SP2023-024: Site Plan for 955 Sids Road

PROJECT NUMBER: SP2023-024
PROJECT NAME: Site Plan for 955 Sids Road
SITE ADDRESS/LOCATIONS: 955 SIDS RD

CASE CAPTION: Discuss and consider a request by David Lindsay of Tri-Tex Construction Inc. for the approval of a Site Plan for an office building on a 1.50-acre tract of land identified as Tract 8-3 of the J. D. McFarland Survey, Abstract No. 145, City of Rockwall, Rockwall County, Texas, zoned Heavy Commercial (HC) District, addressed as 955 Sids Road, and take any action necessary.

DEPARTMENT	REVIEWER	DATE OF REVIEW	STATUS OF PROJECT
PLANNING	Henry Lee	07/19/2023	Needs Review

SITE PLAN

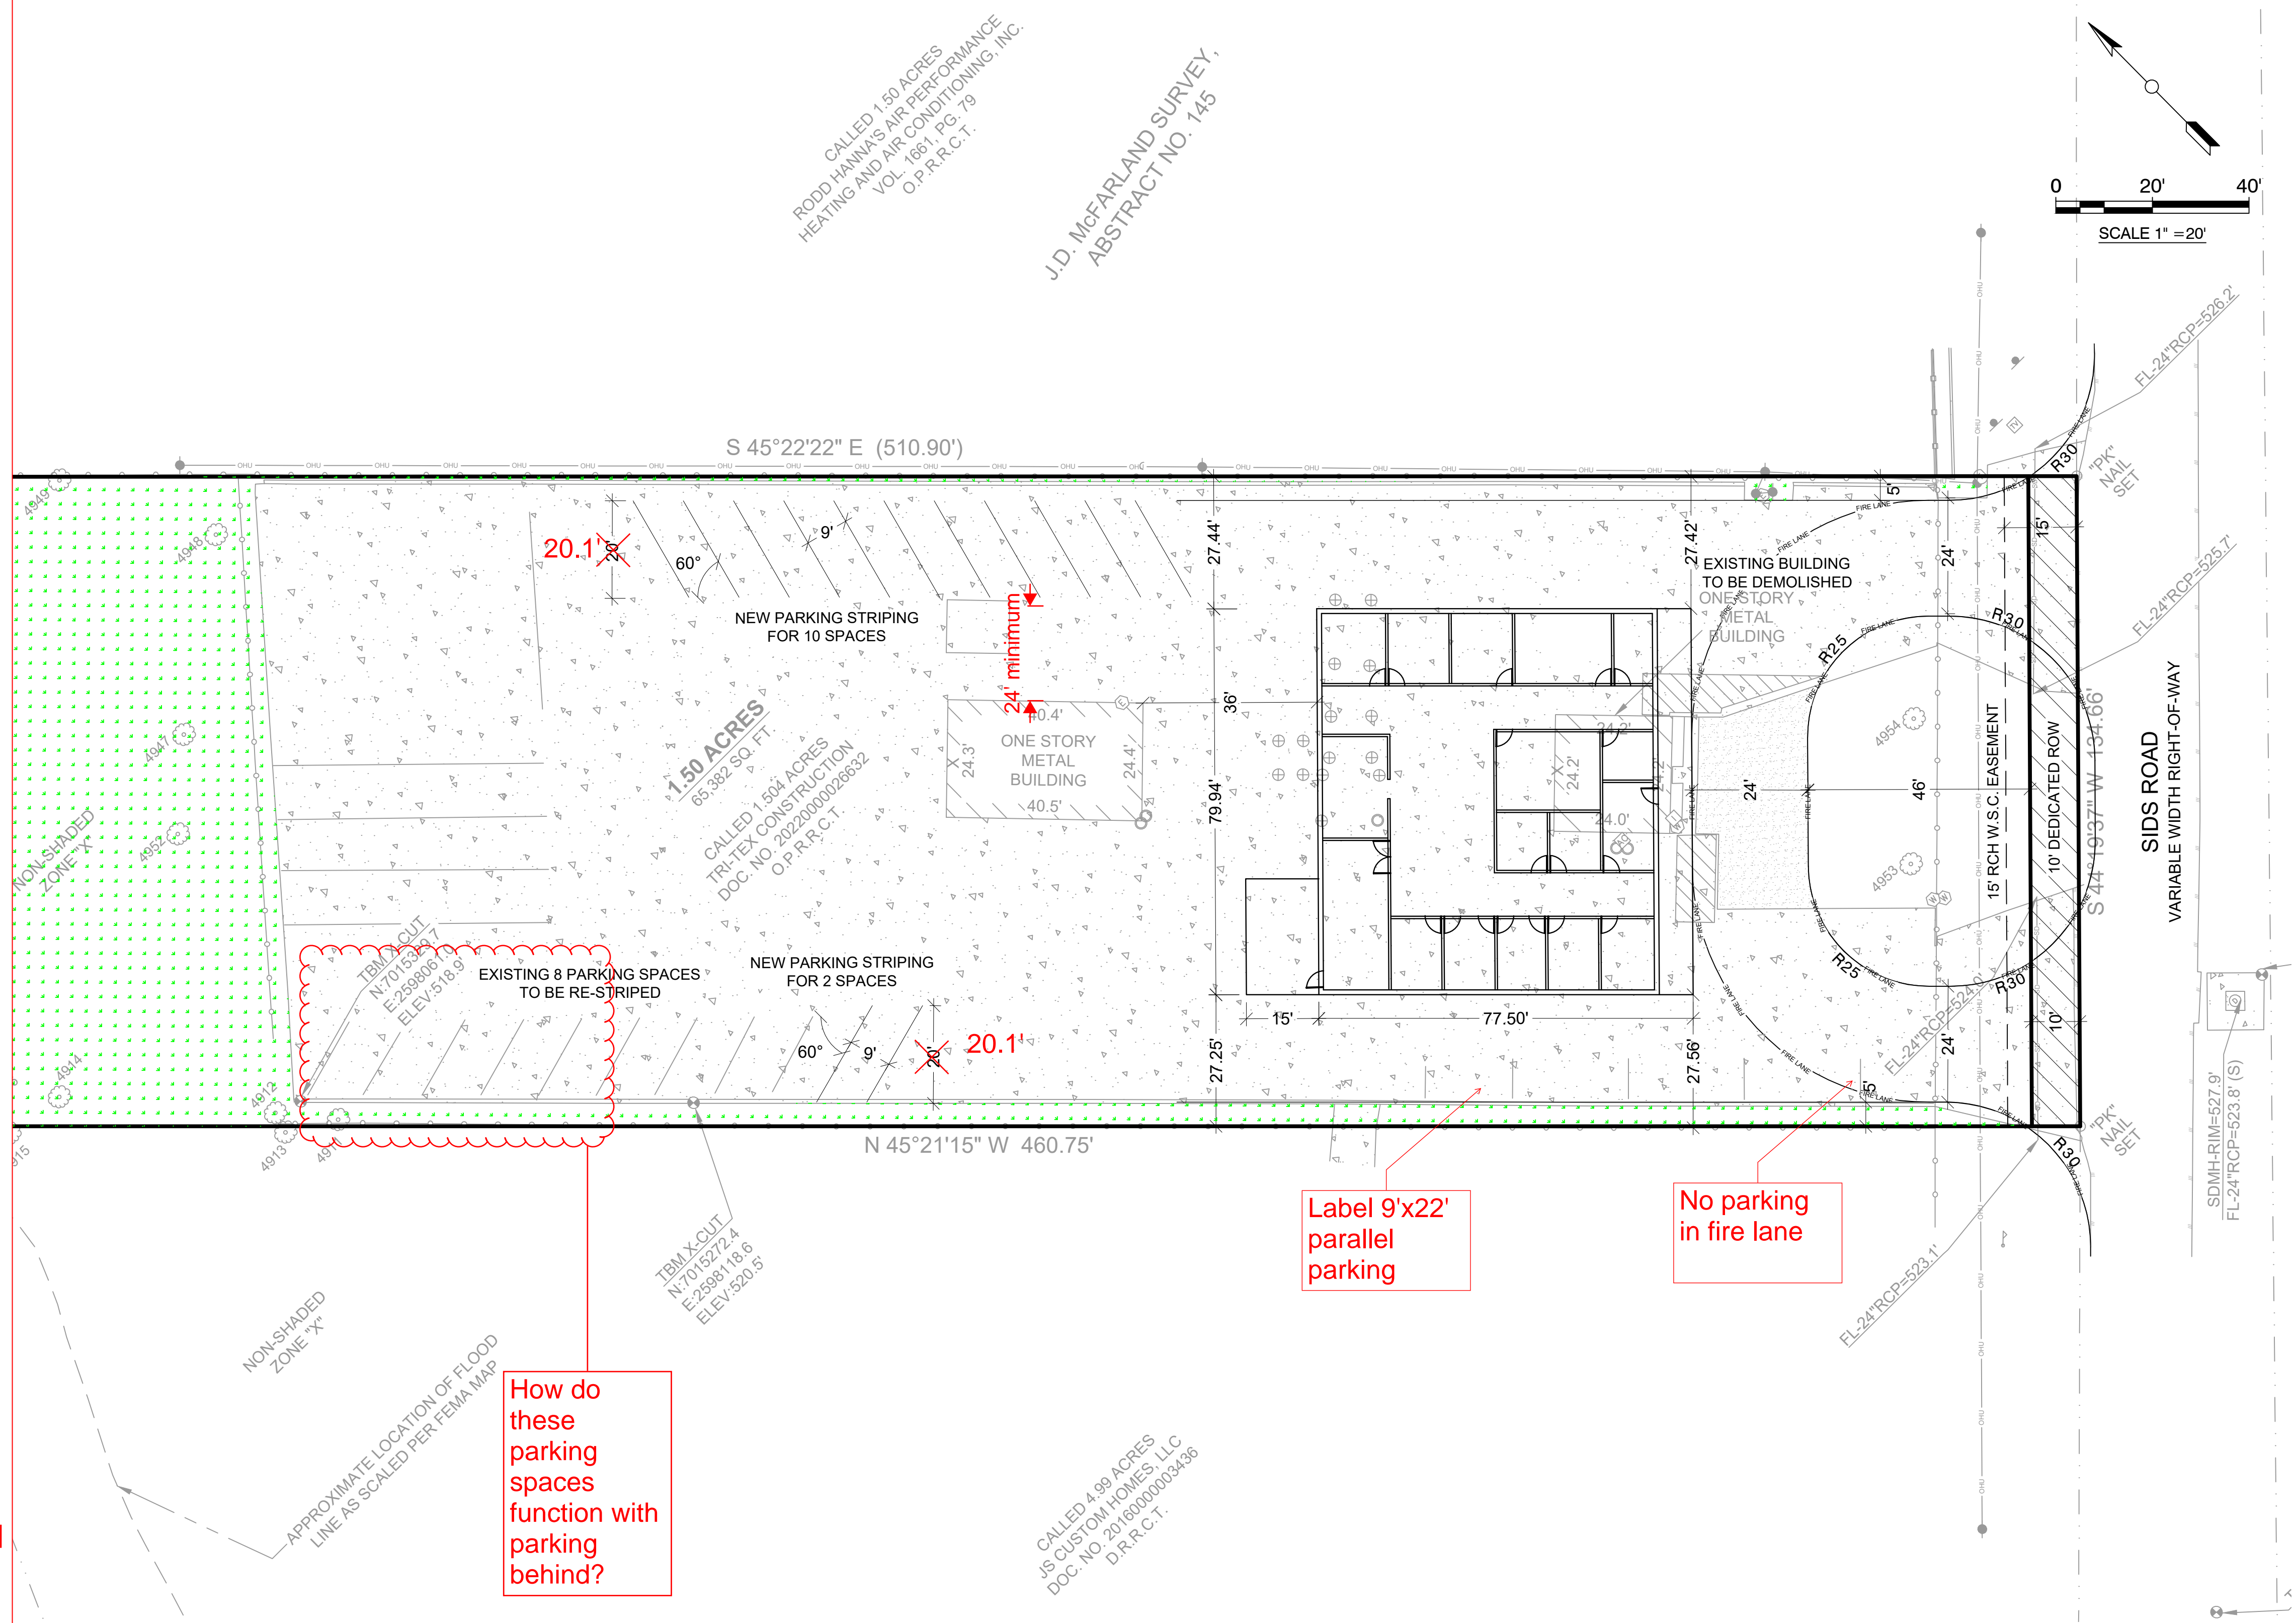
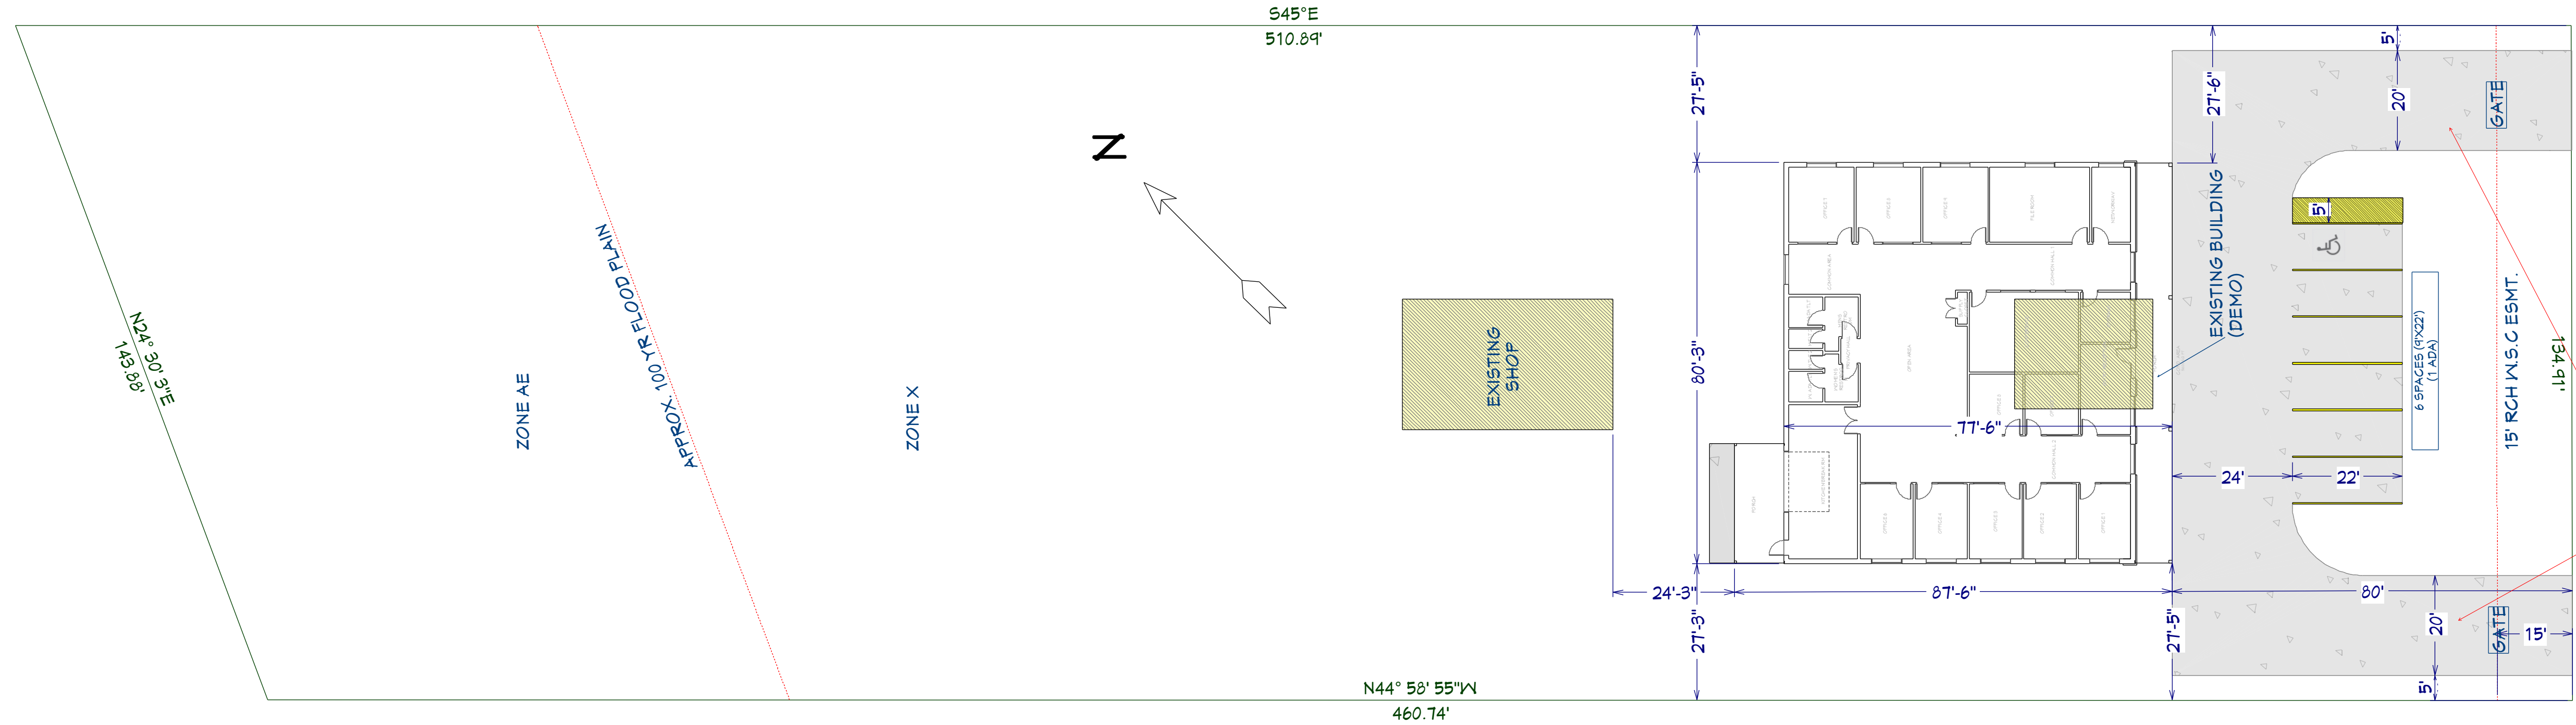
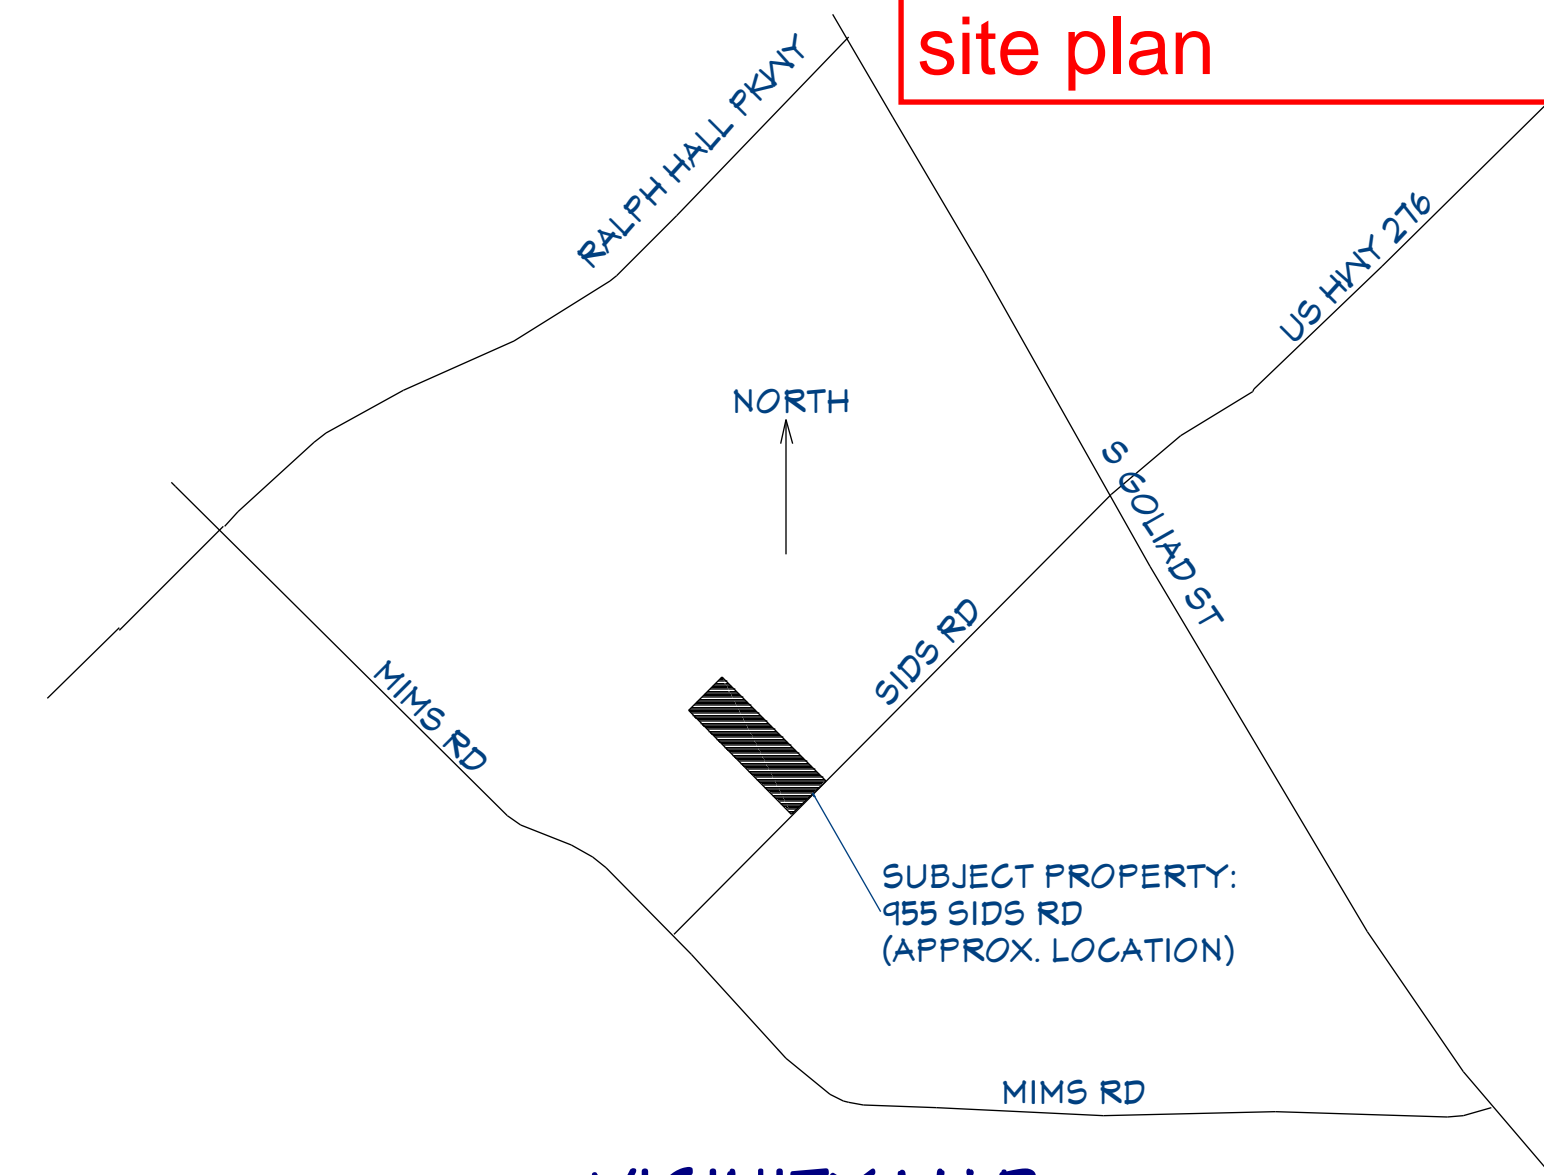
- Must meet City's 2023 Standards of Design and Construction
- 4% Engineering Inspection Fees
- Impact Fees (Water, Wastewater & Roadway)
- Minimum easement width is 20' for new easements. No structures including walls allowed in easements.
- Retaining walls 3' and over must be engineered.
- All retaining walls must be rock or stone face. No smooth concrete walls.
- Show dumpster pad and enclosure.
- Need to show proposed/existing water and sewer on site plan
- Site plan on Sheet 5 doesn't match this site plan. Which one are you requesting?

- No detention in 100yr flood plain.
- Detention is required. Post-Development C value is by zoning.
- No grate inlets allowed
- Dumpster area to drain to an oil/water separator.

- Public water or sewer to be 8" minimum.
- Only one "use" off a dead-end line (domestic, irrigation, fire sprinkler, fire hydrant, etc.)
- Min 20' utility easements.
- Mims Lift Station Pro-rata \$401.89/acre
- May need an on-site fire hydrant

Driveways and drive aisles to be minimum of 24' wide

This site plan doesn't match the other submitted site plan
